FIELD SERVICE ACTION		
To: For the attention of: Please copy to:	All Dealers The Service Manager The Dealer Principal The Parts Manager Aston Martin Technician(s)	Reference: FSA:103
Model:	DB9	Issued: May 2004
VIN Range:	See attached list	
Subject:	Anti Roll Bar Drop Link Fixings	Page: 1 of 5

DB9 – Anti Roll Bar Drop Link Fixings

FIG B- INFILL PAD REVERSE SIDE DUAL LOCK PAD LOCATIONS

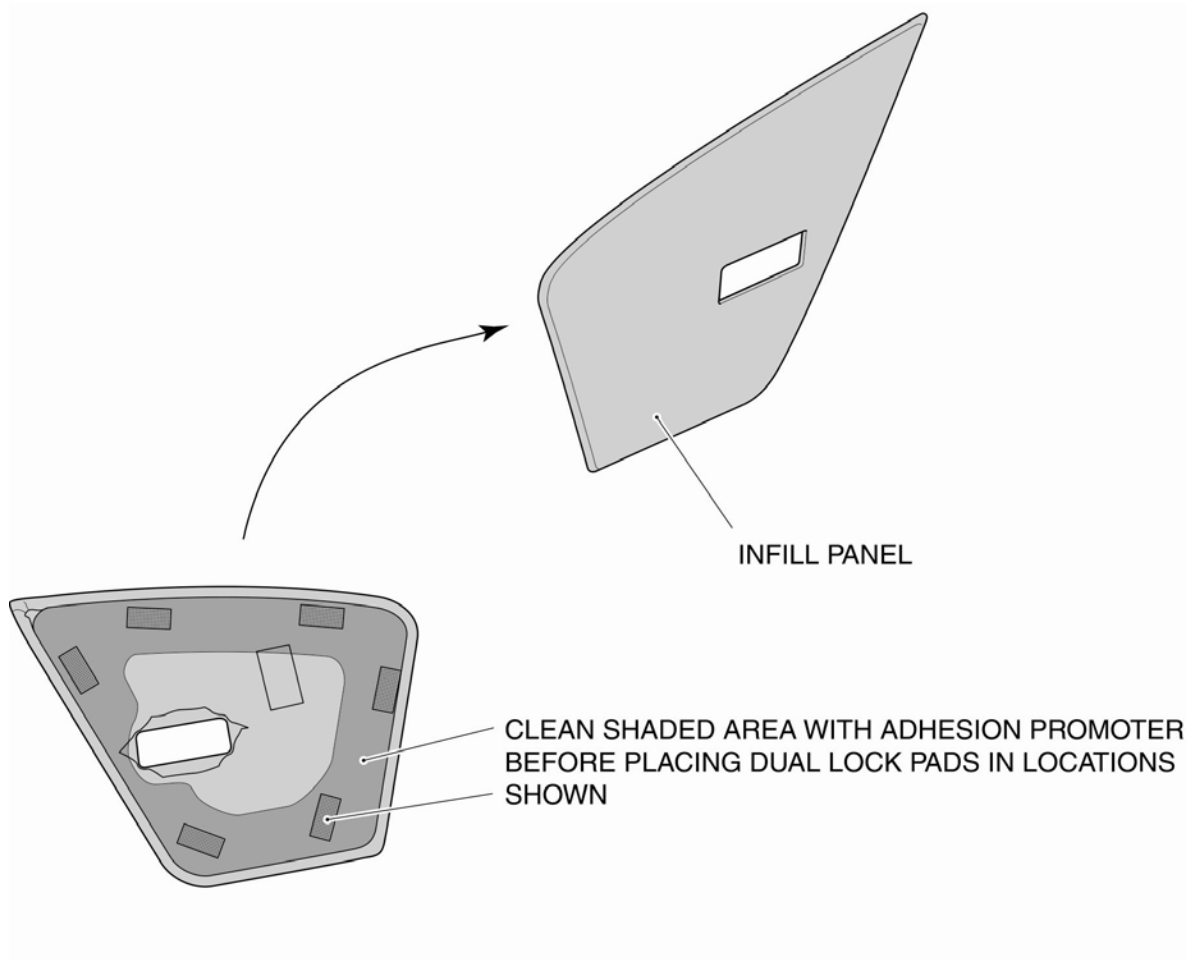
In response to feedback from our Engineering Department, it has been identified that the door infill panel may become detached from the door casing due to high ambient temperature and a reaction with the bonding material.

- Remove the door pull
- Remove the Infill panel from the lower door casing
- Remove any existing tape from both the door casing and Infill panel
- Using 3M Surface Cleaner (Part Number 3M VHB), carefully clean the six locations shown by the arrows in **Fig A**. Ensure none of the previous glue is present
- Using 3M Surface Cleaner (Part Number 3M VHB), carefully clean the darker shaded area shown in **Fig B**. Ensure none of the previous glue is present
- Place the Velcro pads on the door casing in the positions shown by the arrows in **Fig A**
- Place the Velcro pads to the Infill panel so they align with the Velcro pads in the door casing. See **Fig B**
- Align the Infill panel to the door casing and re-fit
- Refit the Door pull
- Repeat procedure for other door

FIGURE 1

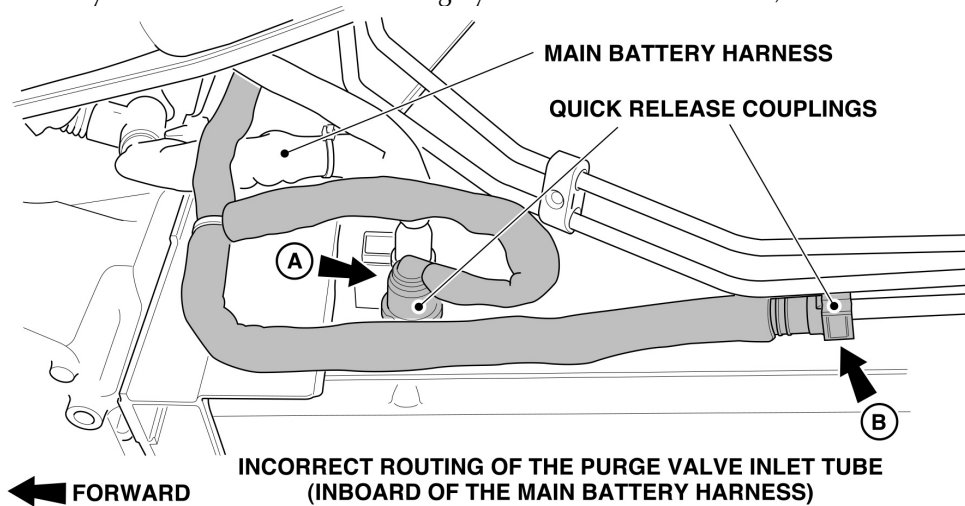
This Field Service Action is therefore being issued to ask the Dealer network to check all vehicles within the affected VIN range and re-route or replace the Purge Valve Inlet Tube as required. Please carry out the following workshop procedure accurately, as the orientation of the Purge Valve Inlet Tube is critical to quality.

- Place the vehicle on a vehicle lift, raise and remove the front under tray. (Early cars will also need the Alternator cooling duct and pipe to be removed)
- Locate the Purge Valve Inlet Tube situated on the right-hand side of the vehicle
- Inspect the Purge Valve Inlet Tube for incorrect routing (see Figure 1 for the incorrect routing) and the latest level heat insulation material (latest material is a bright silver foil like material early cars were fitted with a satin grey silicone flexible material)

- If the Purge Valve Inlet Tube routing is correct and the heat insulation Material is to the latest level, no further action is required
- Refit the front under tray and tighten the retaining screws to 6 to 7Nm
- Lower the vehicle and remove the vehicle protection kit

FIGURE 3

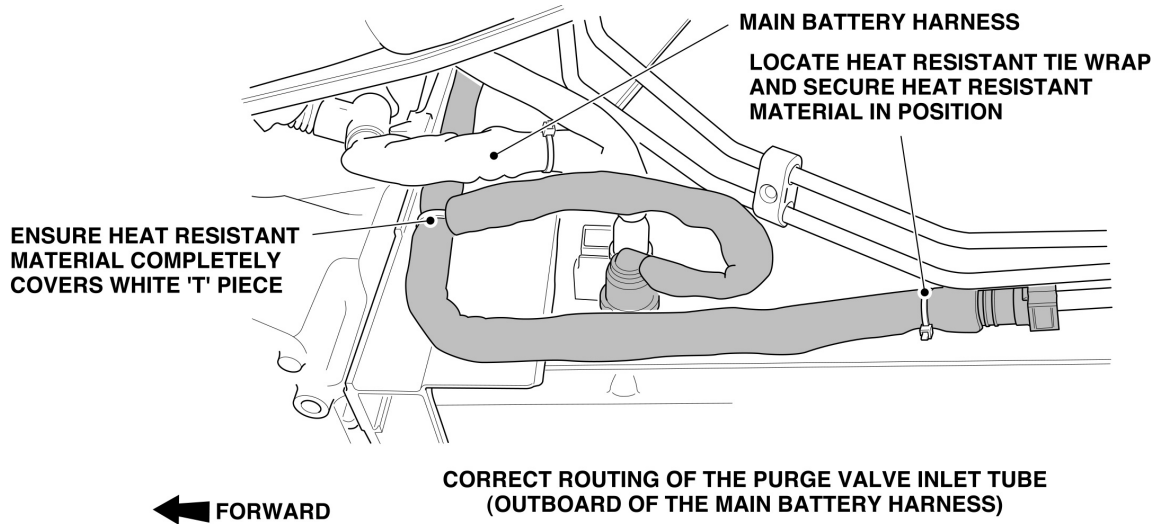
- Carefully feed the Purge Valve Inlet Tube down and out from the vehicle
- Re-route the Purge Valve Inlet Tube to the body side of the main battery harness, as indicated in Figure 3
- Ensuring that both pipes are well clear of steering column on RHD cars
- Reconnect the Purge Valve Inlet Tube at connections A and B
- Place a heat resistant tie wrap around the silver foil heat resistant material as indicated in Figure 3.

Note: - this is to ensure that the white nylon 'T' piece is completely covered by the resistant material – see Figure 3.

FIGURE 1

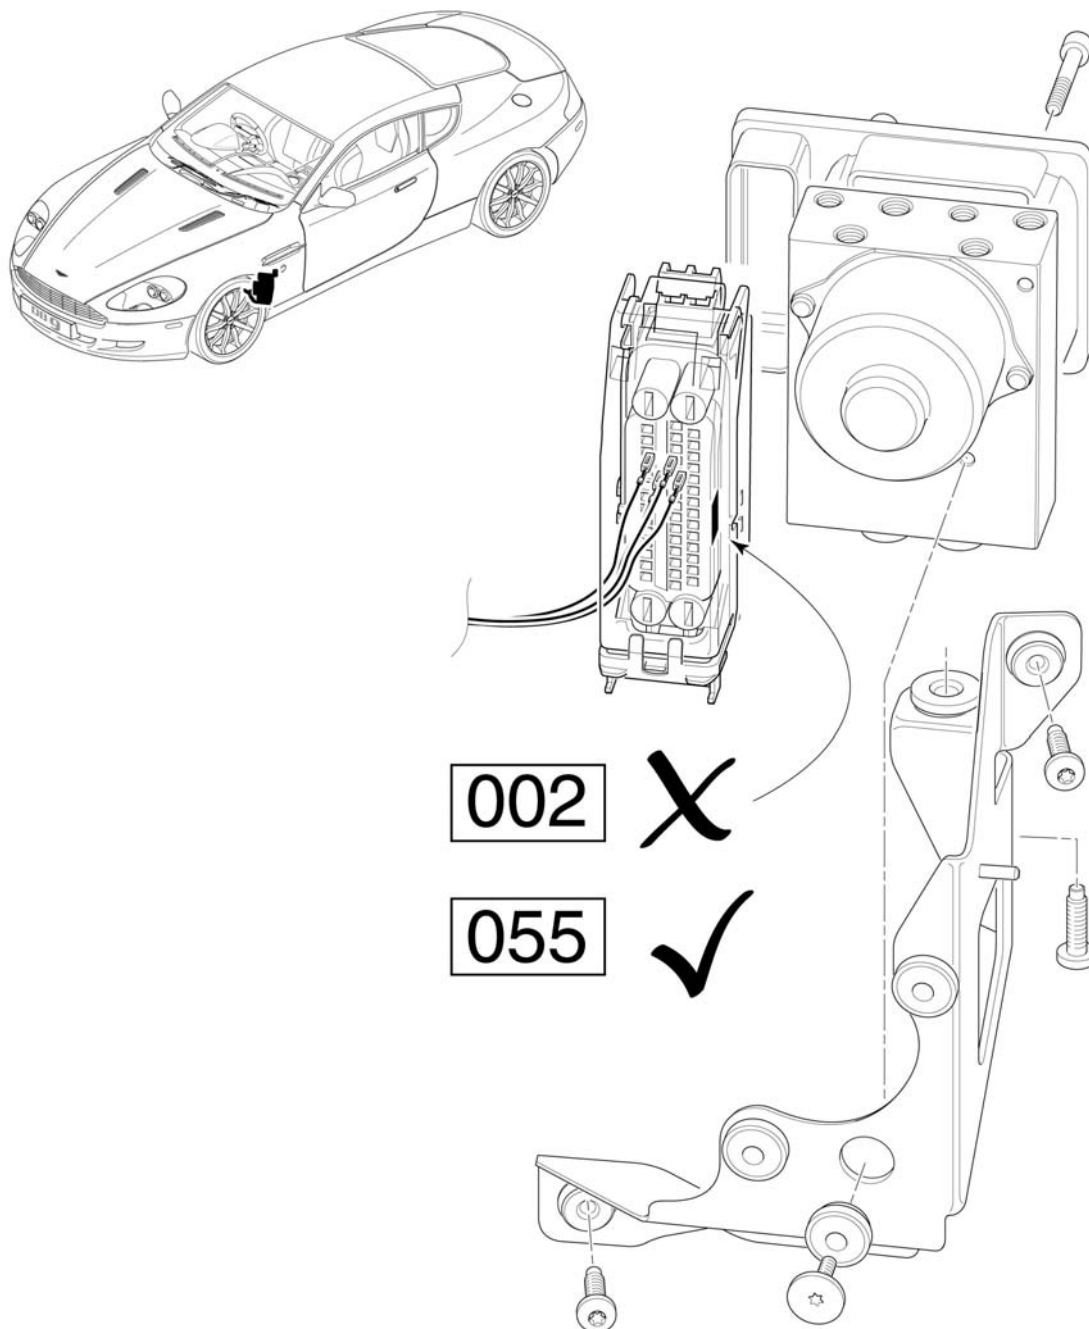
- Remove the LHF wheel and wheel arch liner
- Gain access to the Anti-Lock Braking System Module connector (C0501)
- Check that the connector does require modification (refer to FIG 1). If the connector is marked 002 it will require re-work. If the connector is marked 055 it will NOT require re-work
- Open the cover on connector C0501
- Remove the tie wrap from the housing cable entry
- Using two small flat blade electrical screwdrivers release the terminal locking mechanism of connector C0501, see FIG 2
- Using the table below and FIG 3, insert the wires into the correct connector cavity

FIGURE 1

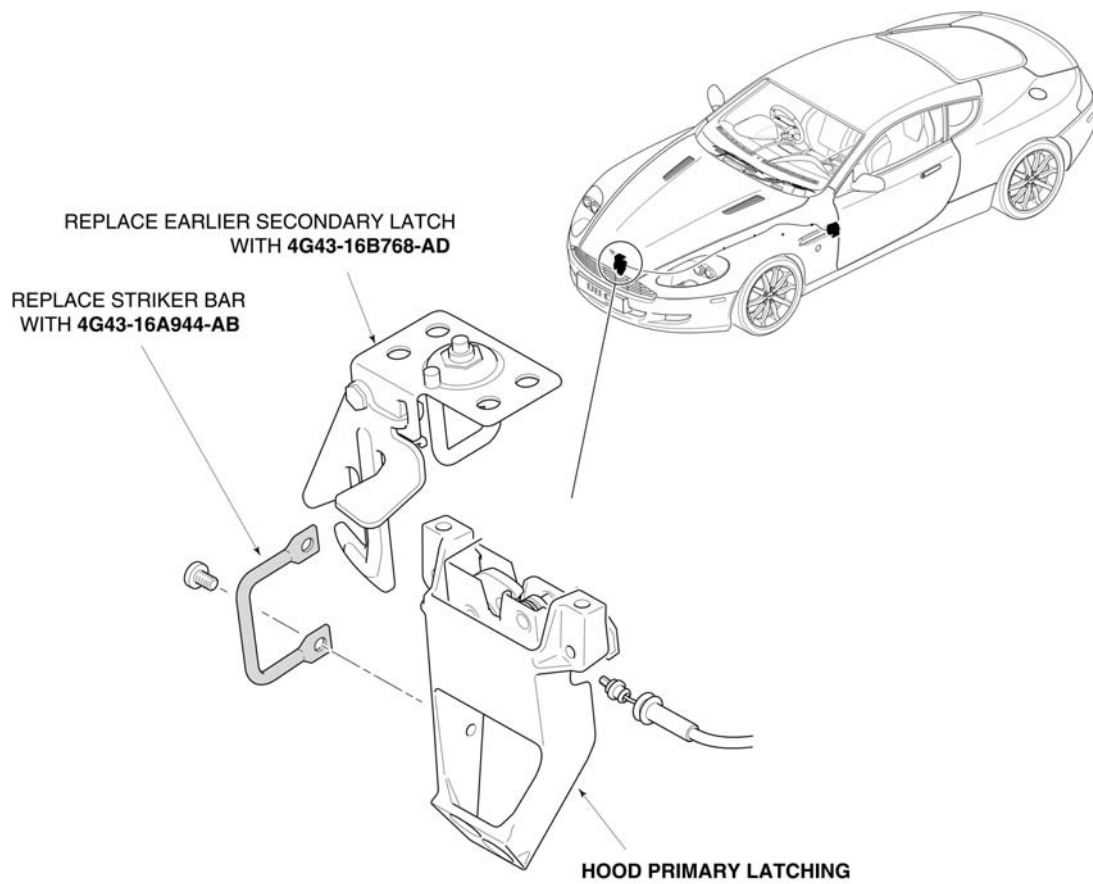
This Field Service Action is therefore being instigated to ensure that all DB9 vehicles within the above listed VIN ranges have their Bonnet Secondary Striker Bar and Latch assemblies inspected and replaced with new parts, (see Figure 1 overleaf).

**FIGURE 3**

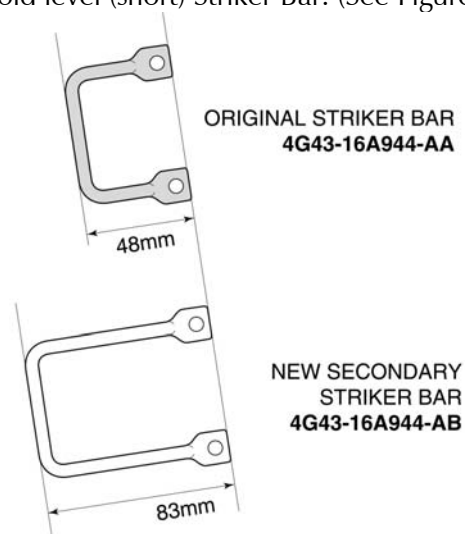
- Fit the new **AD** specification Secondary Latch assembly and tighten the bolts hand tight
- Remove and discard the old level (short) Striker Bar. (See Figure 3 below)

- Fit the new **AB** specification longer Striker Bar to the bumper armature and tighten the bolts to 10.4 Nm +/- 2Nm
- Gently lower the bonnet to check the correct positioning of the Secondary Latch assembly, if incorrect, adjust the secondary mounting plate until the correct position is achieved, see figure 4 overleaf for correct position in relation to Striker Bar. Ensure the Secondary Latch is not pushed to one side, then tighten Secondary bolts to 10.4Nm \pm 2Nm
- Lower the bonnet and check the alignment of the Primary Striker loop to Primary Latch. If incorrect, adjust the position of the Primary latch to correctly locate and align with Primary

**PIVOT TUBE DETAIL SHOWING LOCATING/ RETAINING TANG'S
ON THE BRAKE CLUTCH ACTUATION UNIT (RHD SHOWN)**

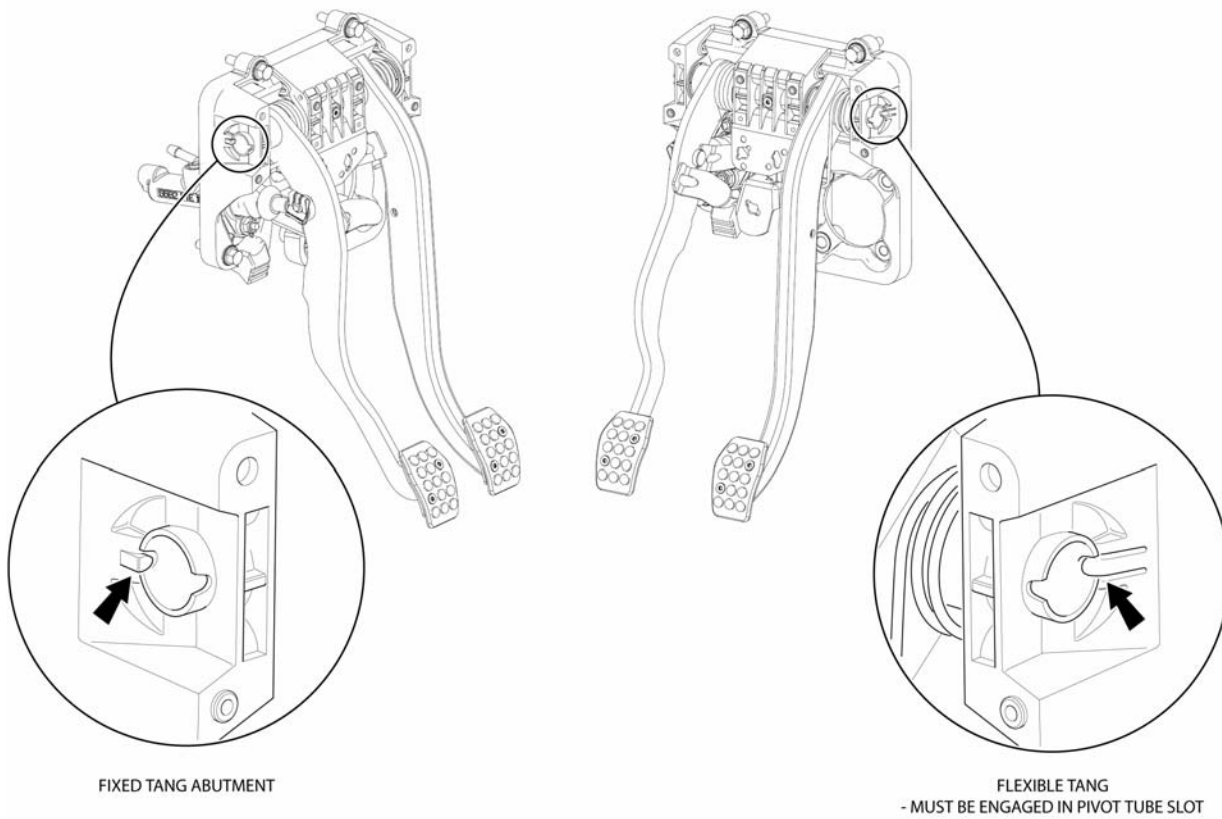
- Ensure that all the relevant DB9 workshop protection kit is fitted
- Locate the Central Pivot Tube locking screw on the Pedal Box assembly (See figure 1 overleaf)
- The screw will be one of two types, either a Torx 25 counter sunk screw or a Phillips POZIDRIV® dome head screw
- Check that the Pivot Tube locking screw is correctly located, if it is, do nothing (do not attempt to tighten it). If the screw is missing, then replace the pedal box assembly
- Also check both ends of the Pivot Tube to ensure that the cut out in the left hand side of the Pivot Tube, is fully engaged into the fixed tang. Now check that the cut out, in the right hand side of the Pivot Tube is fully engaged into the flexible tang. If the Pivot Tube is not seated fully at either end or the flexible tang is missing, replace the Pedal Box assembly (see figure 2 overleaf)
